**MODELS AFFECTED:** 407

**SUBJECT:** WARNING HORNS: FADEC FAIL, ENGINE OUT, AND LOW ROTOR RPM - REPLACEMENT OF.

**HELICOPTERS AFFECTED:** 407, Serial Numbers 53000 through 53194.  
[Serial Number 53195 and subsequent will have the intent of this bulletin completed before delivery.]

Figure 1. Warning horns location

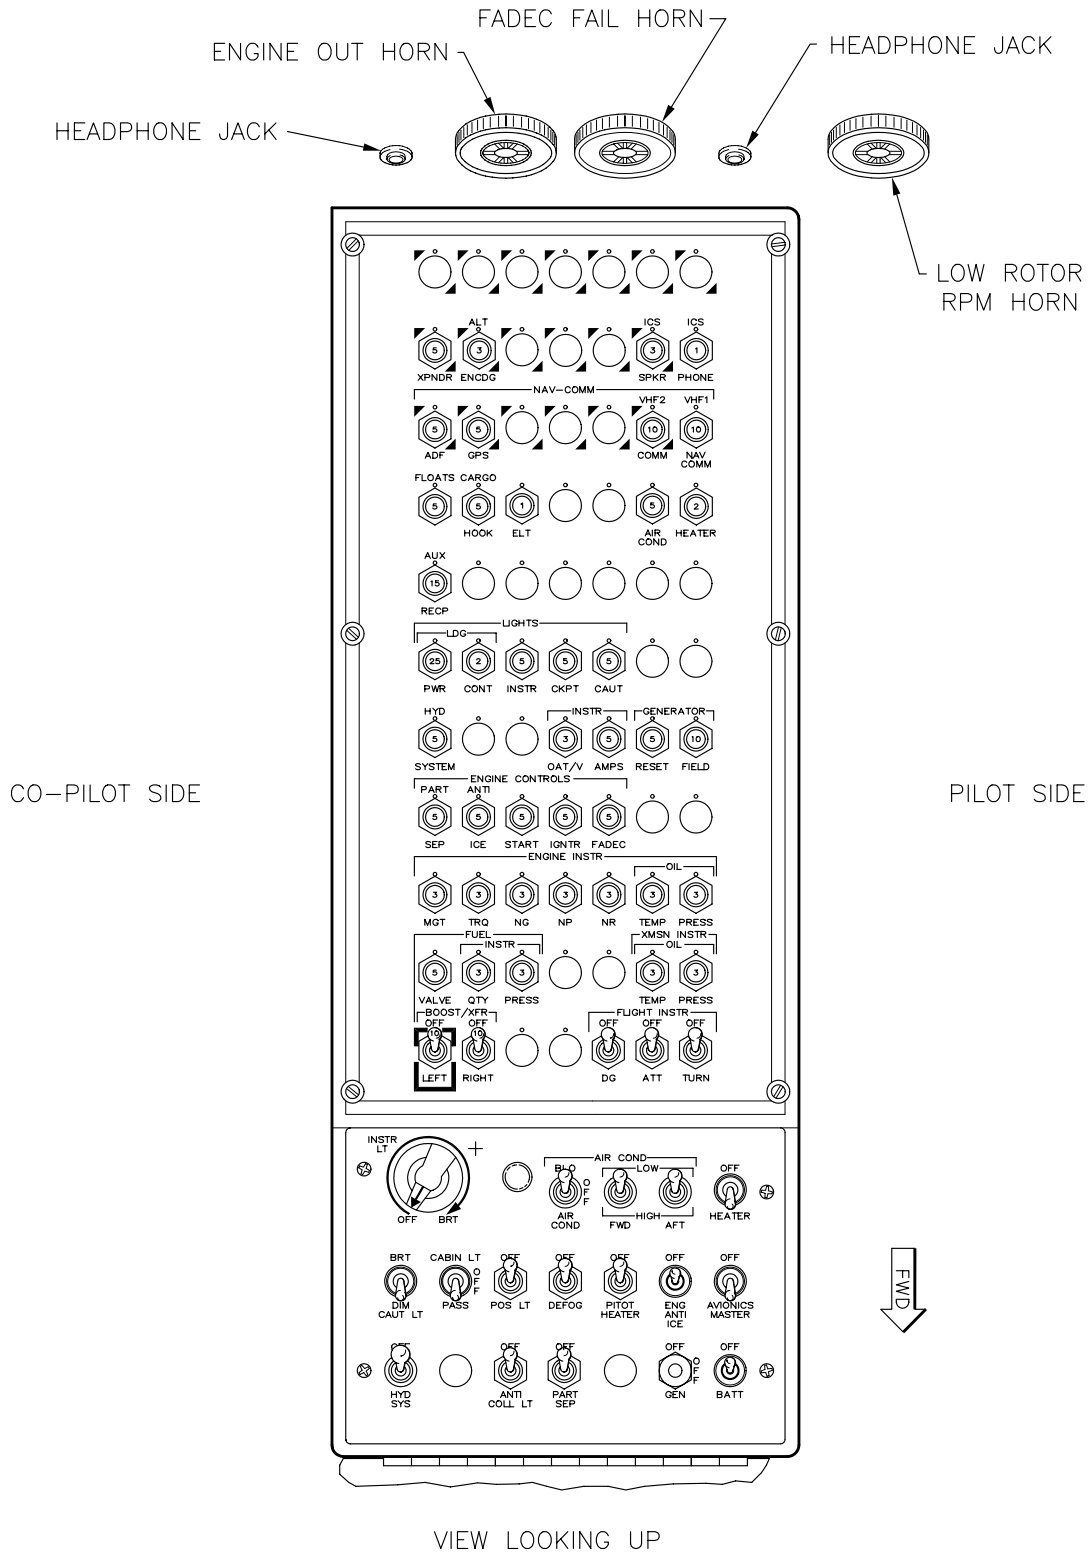
2. Get access to the warning horns aft of the overhead circuit breaker panel.

**Figure 2. Warning horns wiring diagrams**

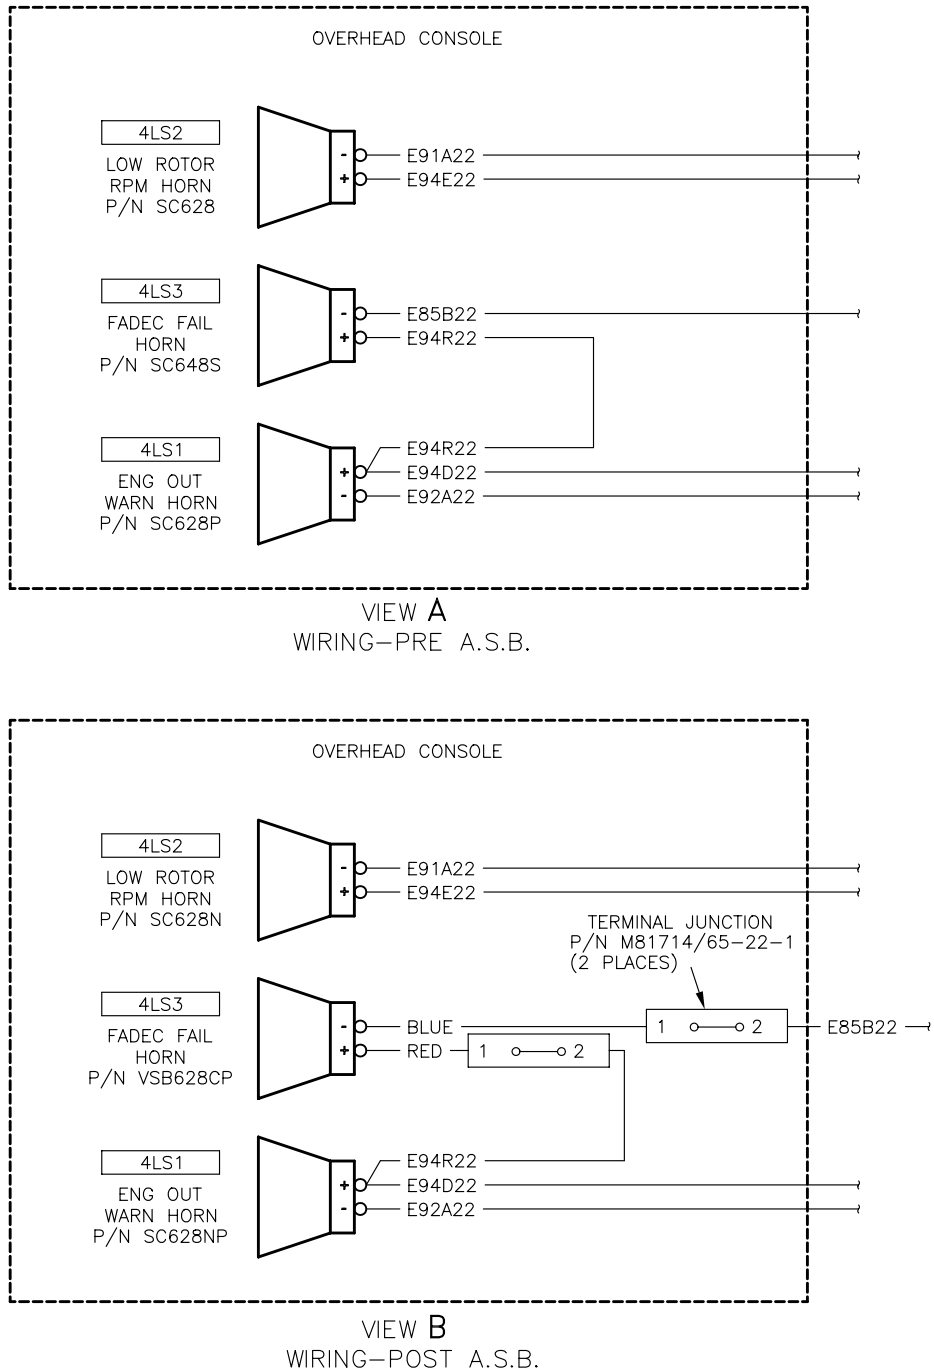
- b. Remove the wires from the horn (Figure 2, View A). Remove the horn.

- e. Use finger pressure or the Insertion/Removal tool to install the contact of the FADEC FAIL horn blue wire and the contact of wire E85B22 into the terminal junction (Figure 2, View B).

- f. Install the contact of the FADEC FAIL horn red wire and the contact of the wire E94R22 into the other terminal junction (Figure 2, View B).

- g. Install the new FADEC FAIL horn. Make sure that the wires are attached correctly and are connected the same as shown in Figure 2, View B.

- a. Remove the wires from the horn (Figure 2, View A). Remove the horn.
  - b. Install the wires E94R22, E94D22 and E92A22 on the new ENGINE OUT horn (Figure 2, View B).

- c. Install the new ENGINE OUT horn. Make sure that the wires are attached correctly and are connected the same as shown in Figure 2, View B.
5. Replace the LOW ROTOR RPM horn as follows:

- a. Remove the wires from the horn (Figure 2, View A). Remove the horn.
  - b. Install the wires E91A22 and E94E22 on the new LOW ROTOR RPM horn (Figure 2, View B).

- c. Install the new LOW ROTOR RPM horn. Make sure that the wires are attached correctly and are connected the same as shown in Figure 2, View B.
6. Install all the parts removed in step 2 to return the aircraft to flight status. Connect the battery.
